Access Compliance Report

Public Rights-of-Way

(Curb Ramps)

Intersection ID: 11431	Main Street: N_GRAHAM_ST	Cross Street: W_9TH_ST	Location: W
ADA ID: E29898FBD2A7	Ramp Type: PerpDiag	Initial Pass/Fail: Pass	Overall Compliance: No
			Severity Score: 25.25

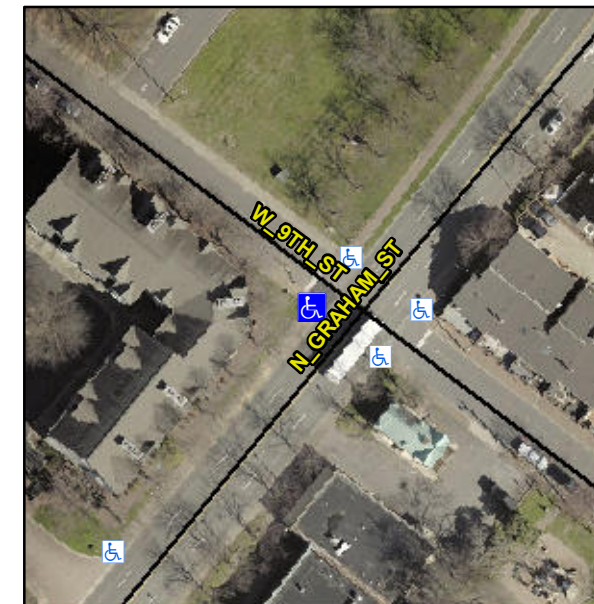
Not Found, R304.5.3, R304.2.1, R304.2.2-Perp, R304.3.2-Para, R305, R304.5.4

Compliance	Description	Data	Compliance	Description	Data
N/A	Ramp Length (in)	43.0	Yes	Ramp Slope (%)	7.3
Yes	Ramp Width (in)	48.0	No	Ramp XSlope (%)	4.2
N/A	Flare Type LT	Sloped	N/A	Flare Type RT	N/A
N/A	Flare Slope LT (%)	6.2	Yes	Flare Slope RT (%)	6.8
N/A	Flare Traversable LT?	Yes	N/A	Flare Traversable RT?	Yes
No	Landing Length (in)	N/A	No	DWS Provided?	No
No	Landing Width (in)	N/A	N/A	DWS Contrast?	No
No	Landing Slope (%)	N/A	N/A	DWS Length (in)	N/A
No	Landing X Slope (%)	N/A	N/A	DWS Full Width?	No
N/A	Landing Curb? (Y/N)	No	N/A	DWS Offset (in)	N/A
N/A	Shared Landing?	No			
Yes	Gutter Ponding?	No	No	Gutter Slope (%)	6.4
Yes	Gutter Lip Ht (in)	0.0	No	Gutter X Slope (%)	7.2
N/A	Painted X Walk1?	No	N/A	Painted X Walk2?	No
	X Walk 1 Direction	To SE		X Walk 2 Direction	To NE
N/A	X Walk 1 Width (in)	N/A	N/A	X Walk 2 Width (in)	N/A
	X Walk 1 Slope (%)	5.6		X Walk 2 Slope (%)	2.2
	X Walk 1 X Slope (%)	2.2		X Walk 2 X Slope (%)	1.4

Remove & Replace Curb Ramp With Two New Directional Ramps or Equivalent. Remove & Replace Gutter.
